Access Compliance Report

Public Rights-of-Way

Intersection ID: 15321	Main Street: CRESTRIDGE_DR	Cross Street: BRIANNA_WY	Location:	E
ADA ID: 8159530366D8	Ramp Type: PerpDiag	Initial Pass/Fail: Fail	Overall Compliance: No	Severity Score: 10

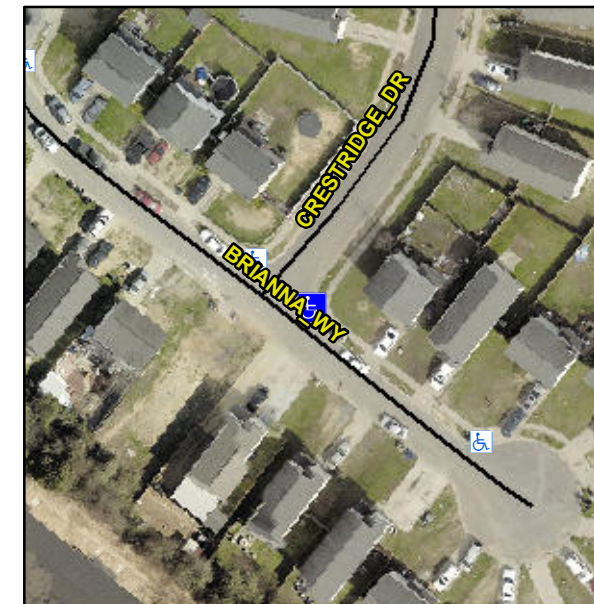
Not Found, R304.5.1, R304.5.3

Compliance	Description	Data	Compliance	Description	Data
N/A	Ramp Length (in)	47.0	Yes	Ramp Slope (%)	5.9
No	Ramp Width (in)	36.0	No	Ramp XSlope (%)	3.0
N/A	Flare Type LT	N/A	N/A	Flare Type RT	N/A
N/A	Flare Slope LT (%)	N/A	N/A	Flare Slope RT (%)	N/A
N/A	Flare Traversable LT?	N/A	N/A	Flare Traversable RT?	N/A
N/A	Landing Length (in)	N/A	N/A	DWS Provided?	N/A
N/A	Landing Width (in)	N/A	N/A	DWS Contrast?	N/A
N/A	Landing Slope (%)	N/A	N/A	DWS Length (in)	N/A
N/A	Landing X Slope (%)	N/A	N/A	DWS Full Width?	N/A
N/A	Landing Curb? (Y/N)	N/A	N/A	DWS Offset (in)	N/A
N/A	Shared Landing?	N/A			
N/A	Gutter Ponding?	N/A	N/A	Gutter Slope (%)	N/A
N/A	Gutter Lip Ht (in)	N/A	N/A	Gutter X Slope (%)	N/A
N/A	Painted X Walk1?	No	N/A	Painted X Walk2?	No
	X Walk 1 Direction	To NW		X Walk 2 Direction	To SW
N/A	X Walk 1 Width (in)	N/A	N/A	X Walk 2 Width (in)	N/A
	X Walk 1 Slope (%)	3.4		X Walk 2 Slope (%)	3.6
	X Walk 1 X Slope (%)	2.4		X Walk 2 X Slope (%)	2.0

Remove & Replace Curb Ramp With Two New Directional Ramps or Equivalent.
